LAND USE DIVISION INTEROFFICE MEMORANDUM

RE: SUBDIVISION REQUIREMENTS - IN THE MATTER OF THE VALADAO, APPLICATION # PLN-2021-17560 FMS, APN 510-381-021, FOR APPROVAL OF A TENTATIVE MAP, CONSISTING OF 2.47 ACRES INTO 17 LOTS

DATE: 01/09/2023
10/25/2023 revised TM

These recommendations are based on the revised tentative map prepared by Kelly-O’Hern dated April 2023, revised May 10, 2023 and received electronically by the Humboldt County Planning Division on September 29, 2023.

Above: Typical section for widening Pickett Road

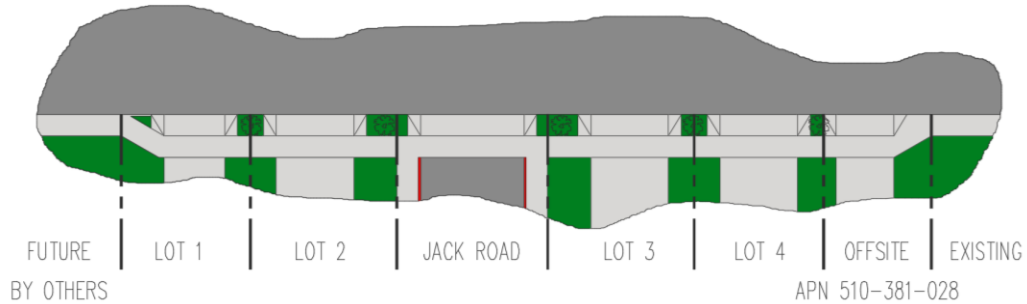
- (a) **Pickett Road (County Road No. 4M030)** shall be constructed having a typical section comprised of two 12 foot wide driving lanes, an 8 foot wide parking lane, a 5' wide landscape strip (4.5' wide useable) and 5' wide pedestrian sidewalk with Caltrans Type A2-6 portland cement concrete (PCC) curb and gutter fronting the subject parcel.

Above: Typical section for widening Gwin Road

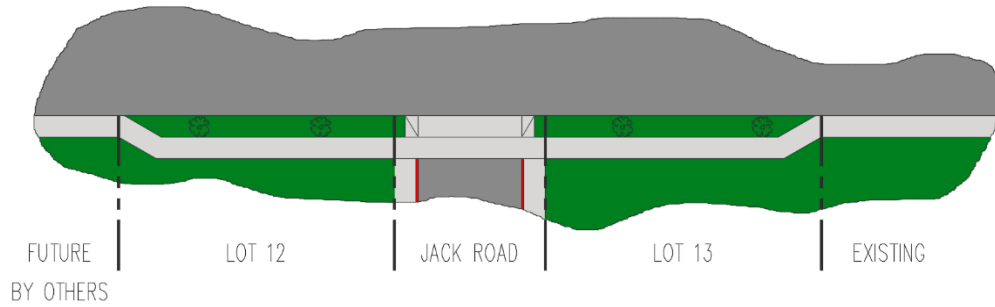
- (b) **Pickett Road (County Road No. 4M030) OFFSITE:** construct in fill curb, gutter, sidewalk, and urban driveway No. 1 across the frontage of APN 510-381-028. (This was the former access to the subject property.)
- (c) **Gwin Road** shall be constructed having a typical section comprised of two 12 foot wide driving lanes, an 8 foot wide parking lane, a 5' wide landscape strip (4.5' wide useable) and 5' wide pedestrian sidewalk with Caltrans Type A2-6 portland cement concrete (PCC) curb and gutter fronting the subject parcel.

Above: Typical section for Jack Road

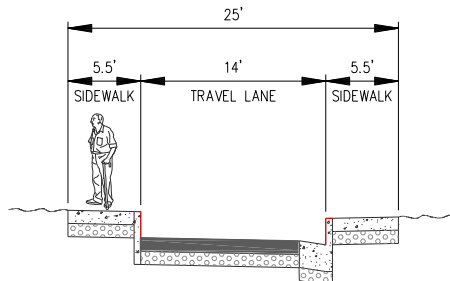
- (d) **Jack Way** shall be constructed 24' in width with a 3' wide concrete valley gutter in the center of the roadway. A 5' wide sidewalk shall be provided along both sides of the road. Where parking stalls are provided, the road shall have a 16' deep parking stall with Caltrans Type A1-6 curb and 7 foot wide sidewalk.

Parking stalls shall be a minimum of 9 feet wide in order to utilize a 24 foot wide roadway. A wider roadway is necessary if narrower parking stalls are desired.

Above: Diagram showing landscape medians where perpendicular parking is provided.

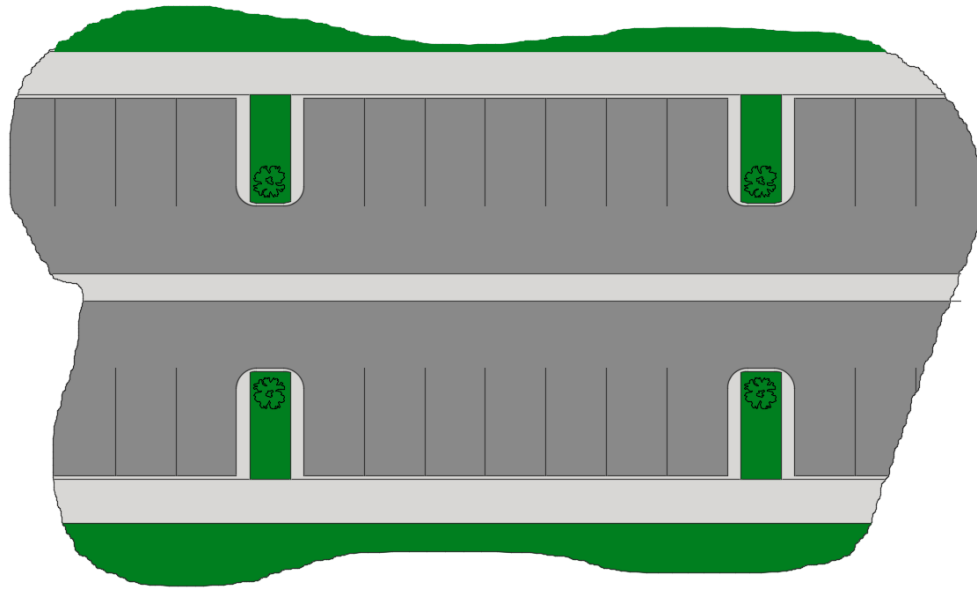
Where perpendicular parking is provided, provide landscaped medians periodically, roughly at each lot line
